Date: July 6, 2009

**ADDENDUM No. 5 TO THE CONTRACT DOCUMENTS**

**6<sup>TH</sup> FLOOR ASBESTOS ABATEMENT, RENOVATION, BUILDING RESKIN, AND CENTRAL UTILITY  
PLANT  
DEPARTMENT OF MOTOR VEHICLES  
HEADQUARTERS BUILDING  
SACRAMENTO, CALIFORNIA**

PROJECT NO. 118141

4. SHEET E7.1  
Numbered Note 2

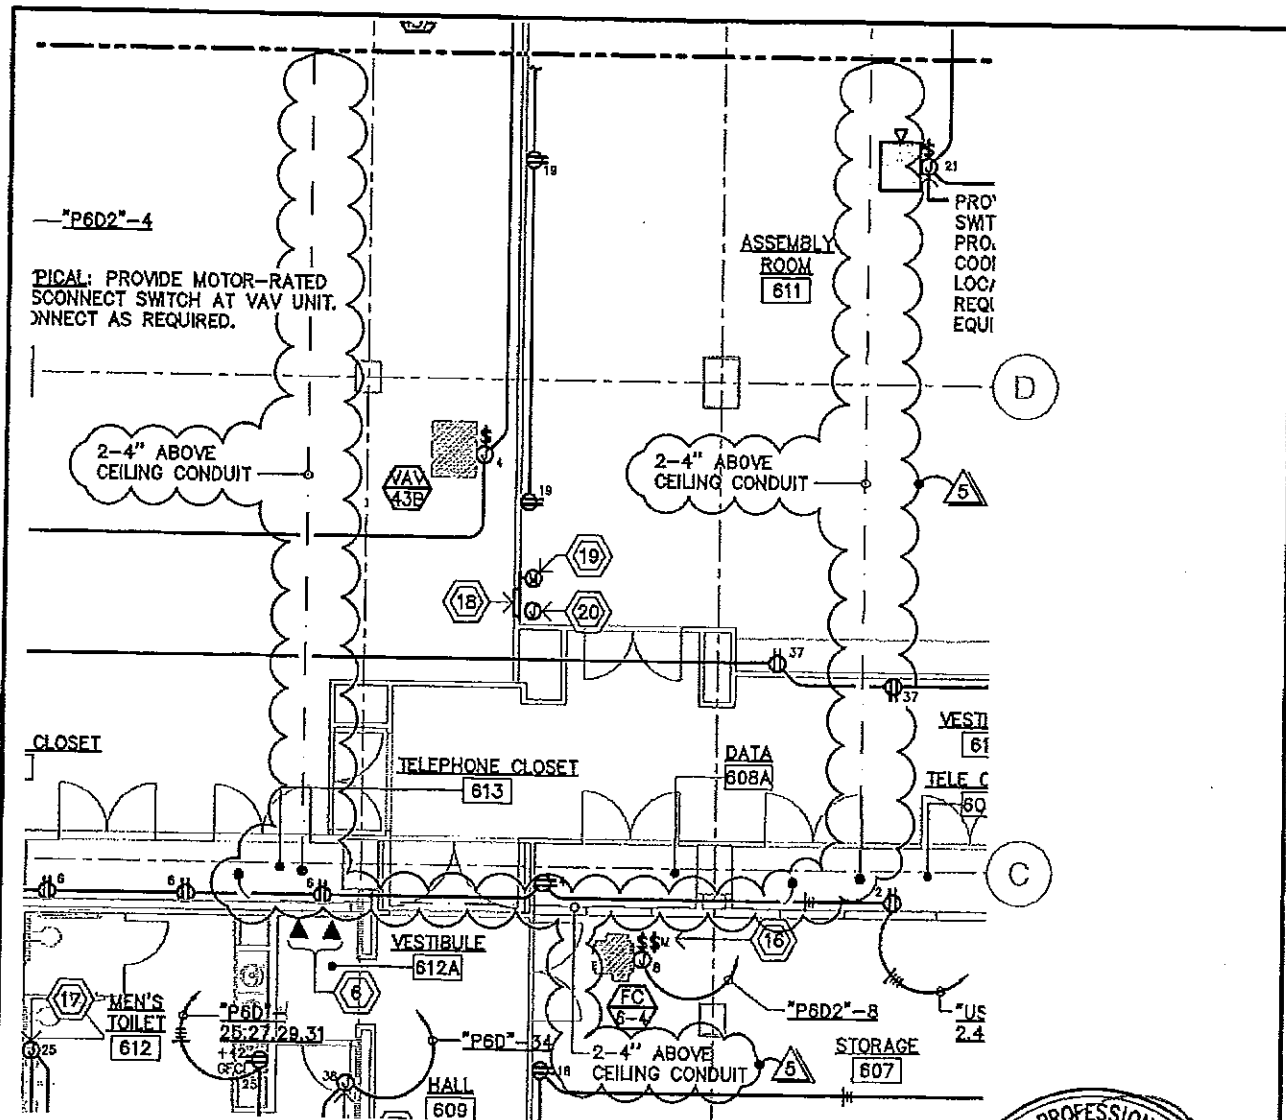
CHANGE the photovoltaic Square D 600VDC disconnect switch part number from Square D Model #H363RB to #H364RB.

PROJECT:	DMV 6th Floor, Reskin, CUP		
REVISION:	Addendum 5	JOB NO:	24122
REFERENCE:	E2.6A	SCALE:	As Noted
DATE:	7/6/09	DRWG:	E-1

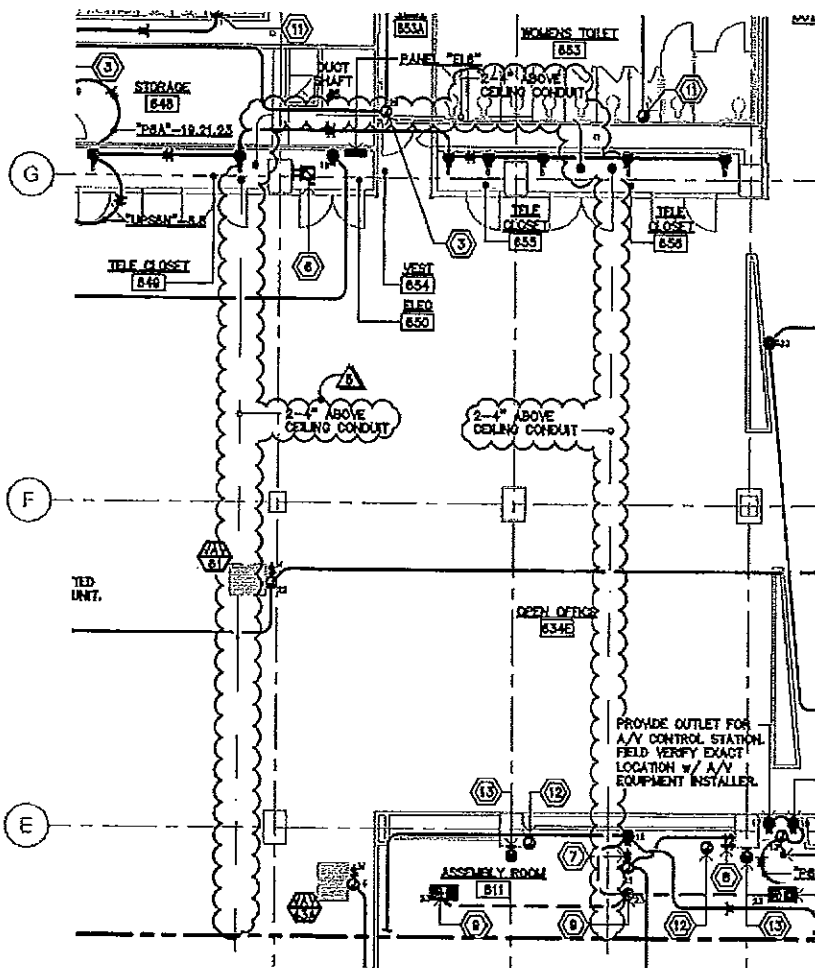
ADD above ceiling conduits connecting Tele Closets per Addendum No. 5 Drawing E-1 dated 7/06/09; showing (2) 4" conduits connecting Tele Closet 613 to Tele Closet 608B; Tele Closets 608B to Tele Closet 656; Tele Closet 613 to Tele Closet 649.

PROJECT:	DMV 6th Floor, Reskin, CUP	
REVISION:	Addendum 5	JOB NO: 24122
REFERENCE:	E2.6B	SCALE: As Noted
DATE:	7/6/09	DRWG. E-2

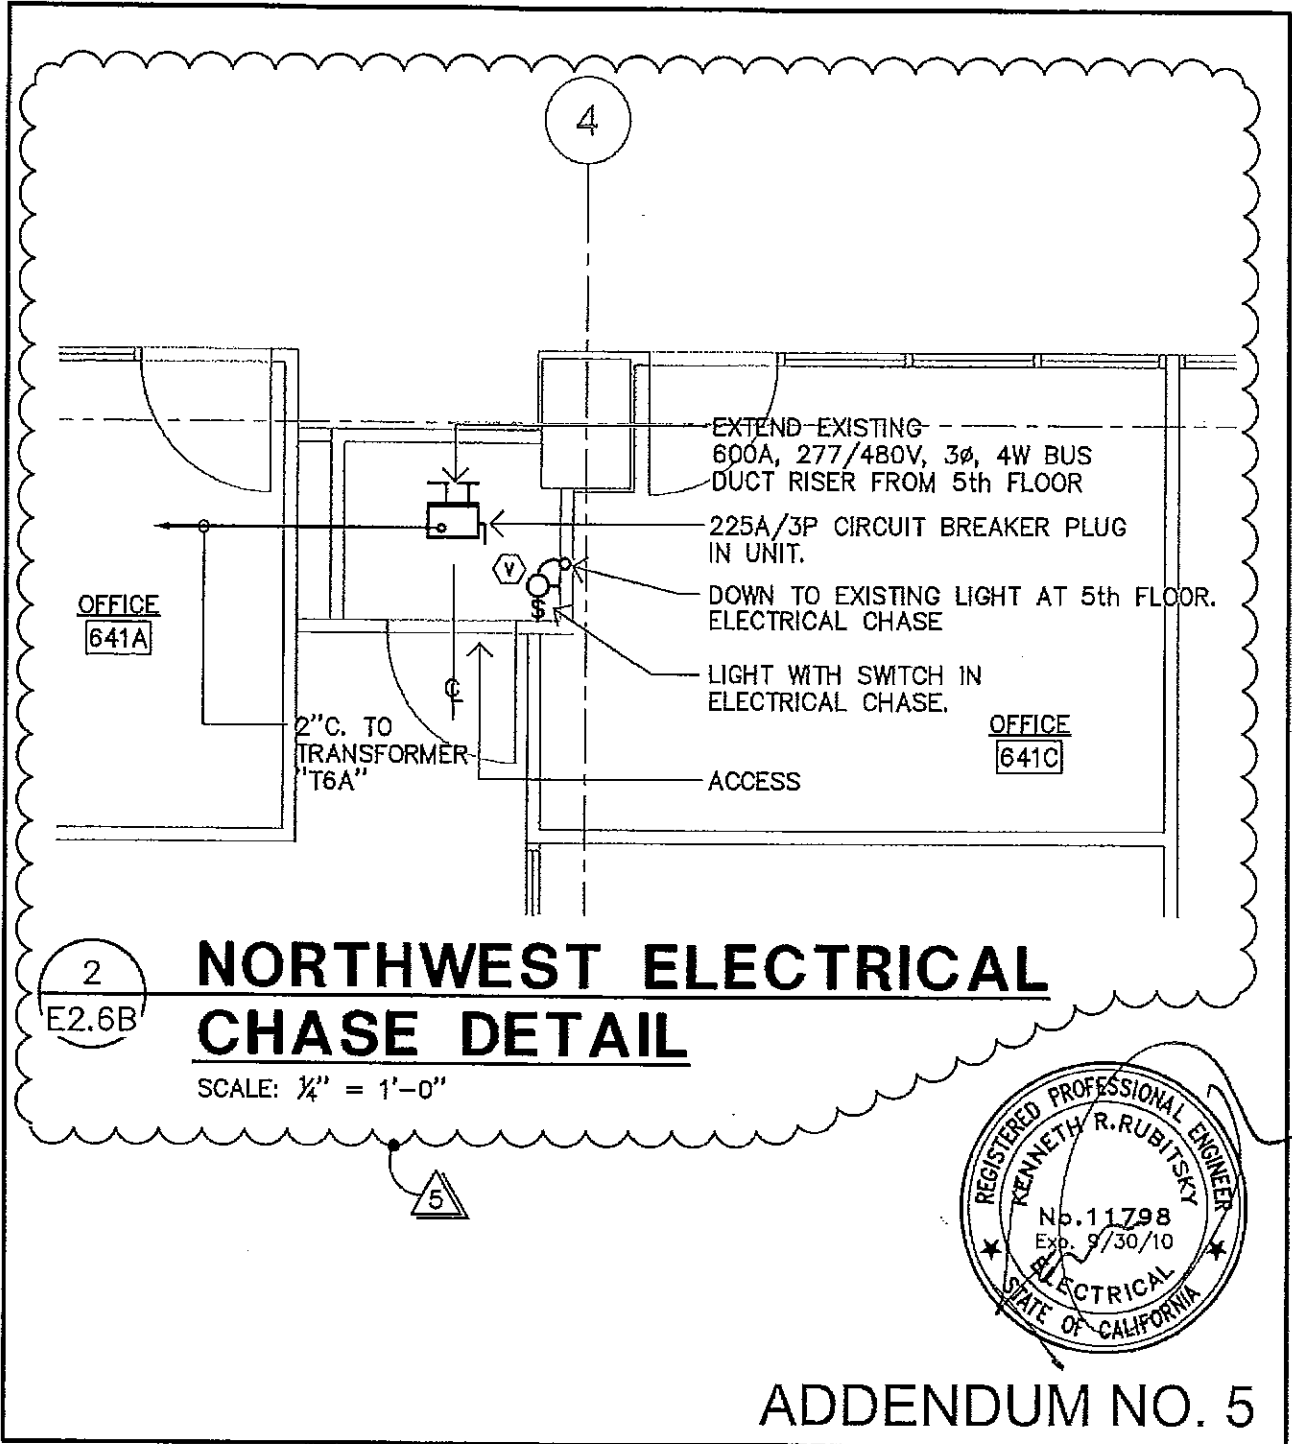
ADD above ceiling conduits connecting Tele Closets per Addendum No. 5 Drawing E-2 dated 7/06/09; showing (2) 4" conduits connecting Tele Closet 649 to Tele Closet 656; Tele Closets 656 to Tele Closet 608B; Tele Closet 649 to Tele Closet 613.

PROJECT:	DMV 6th Floor, Reskin, CUP
REVISION:	Addendum 5
REFERENCE:	E2.6B
DATE:	7/6/09
JOB NO:	24122
SCALE:	As Noted
DRWG.	E-3

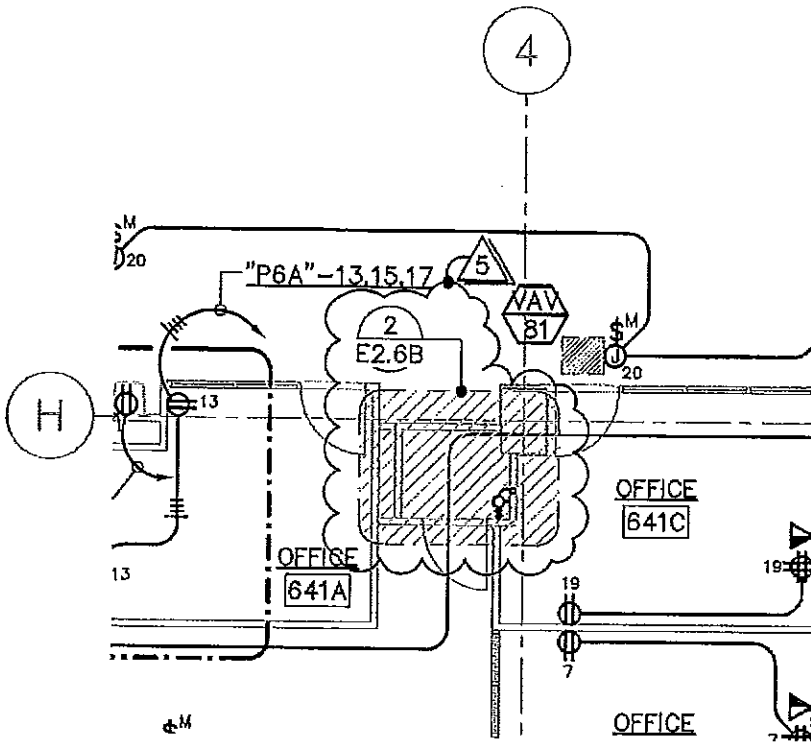
ADD detail 2/E2.6B per Addendum No. 5 Drawing E-3 dated 7/06/09; showing extended bus duct riser from 5<sup>th</sup> floor to 6<sup>th</sup> floor and electrical equipment in chase.
